## Report on a Publicly Notified Resource Consent Application

(Section 42A)

<b>Application Reference:</b>	RMA/2019/1330
<b>Applicant:</b>	Collett's Corner Limited
<b>Site address:</b>	25 Oxford Street and 3, 5, 7 and 9 London Street
<b>Legal Description:</b>	Lot 1 DP 13544 and Pt Sec 31 Lyttelton Town
<b>Proposal:</b>	New three-storey building containing a health spa, restaurant, gymnasium, offices, retail activity and 26 residential units or guest accommodation (revised to 20 units after notification)
<b>Zoning:</b>	Commercial Banks Peninsula Zone
<b>Overlays and map notations:</b>	Liquefaction Management Area (LMA); Banks Peninsula District Plan Coastal Hazards; Coastal Environment; Ngā Tūranga Tūpuna (65, Ōhinehou (Lyttelton) settlement and port, listed in Appendix 9.5.6.3 Table 3: Ngā Tūranga Tūpuna); and Hill Waterway – Oxford Street Drain
<b>Activity status:</b>	<b>Discretionary</b>
<b>Submissions:</b>	135 in support 32 in opposition 2 that do not state a position (34 of these submitters seek to be heard) A list of submitters is at <b>Attachment 1</b> to this report.

02 west elevation  
scale 1:200 @ A3

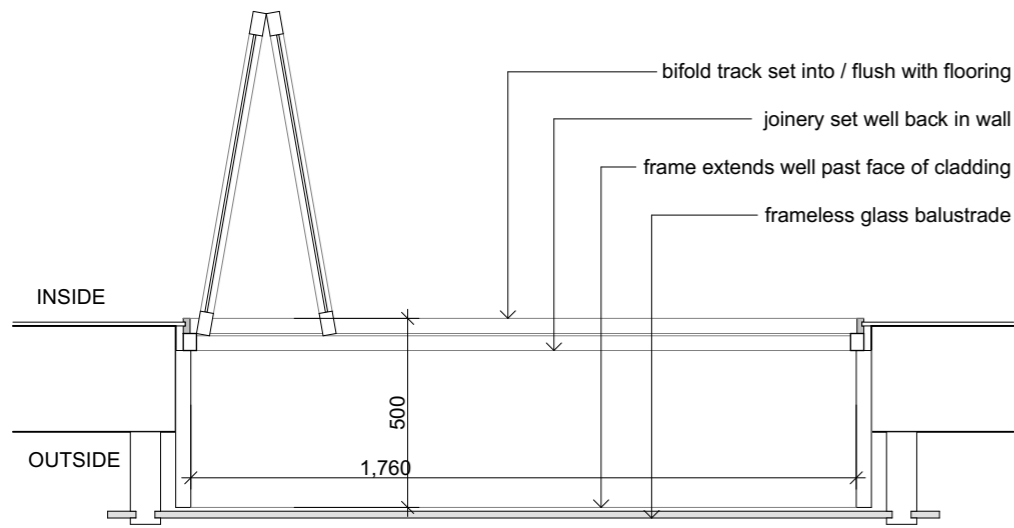
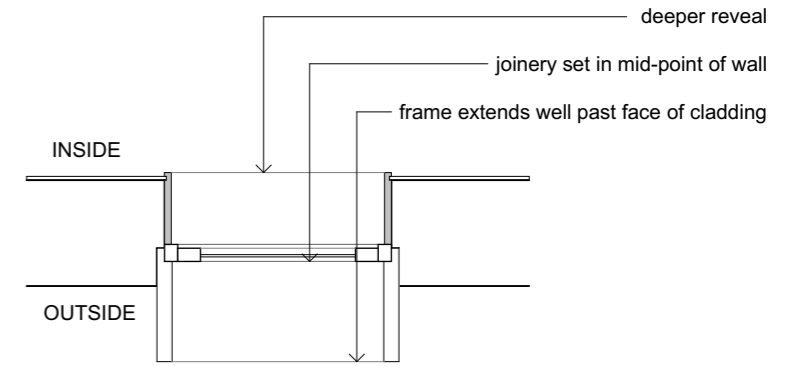
A concern with the notified proposal was the scale of modules and the use of a single material, combined with insufficient detailing. The revised proposal includes more detailing and articulation. Each floor is clearly identifiable on all sides and the windows, which are strong vertical elements, have been arranged to provide vertical divisions. For instance, this mechanism splits each form facing London Street into two or three.

The materials have been revised since the proposal was notified. The tile cladding is proposed to be replaced with a metal cladding with a variety of patterns. These would cover the upper floors, with some additional variety being provided by coloured window framing. The ground floor consists of glazing and patterned concrete.

**A** juliet balcony detail  
scale 1:20 @ A3

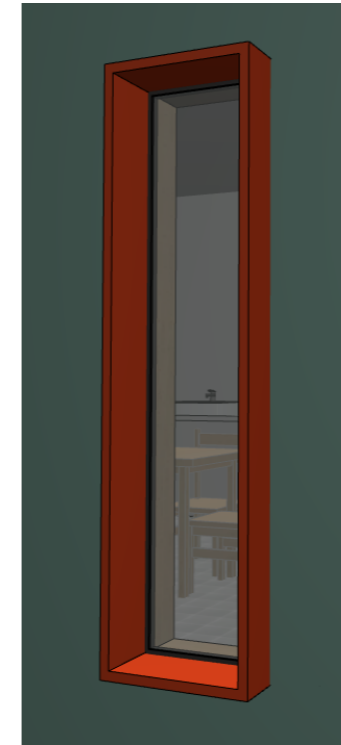
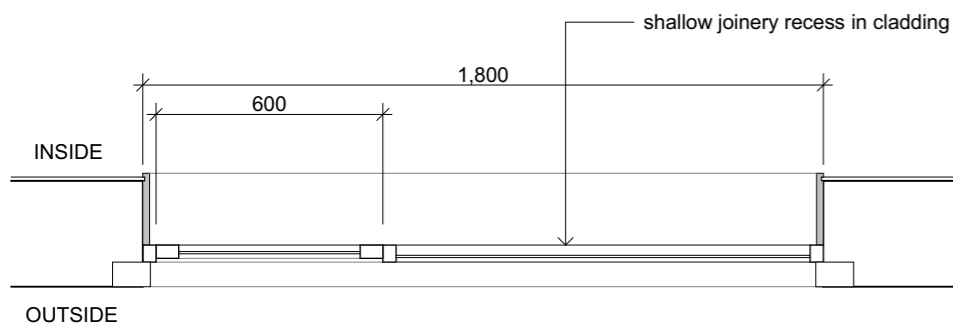
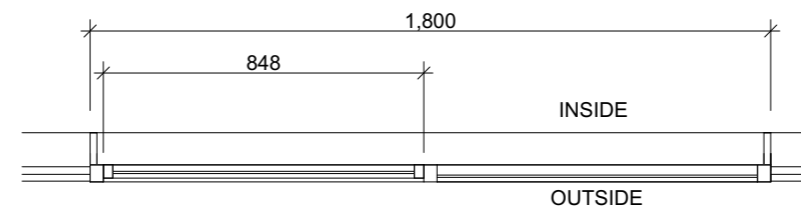
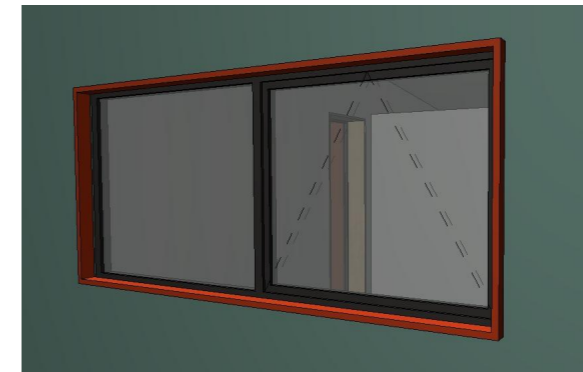
The proposal has been revised to provide more detail in relation to this matter. It includes balconies and windows with a variety of framing, including protruding surrounds. There is also a variety in cladding proposed. The revisions have substantially improved the proposal and this matter is now met.

- Developed window details to show a range of window types and their location and to demonstrate the proposed Juliet balcony windows;
3. The proposed changes will not result in any additional non-compliances, while the existing non-compliances that were proposed under RMA/2019/1330 are detailed above and below in the transport amendments.
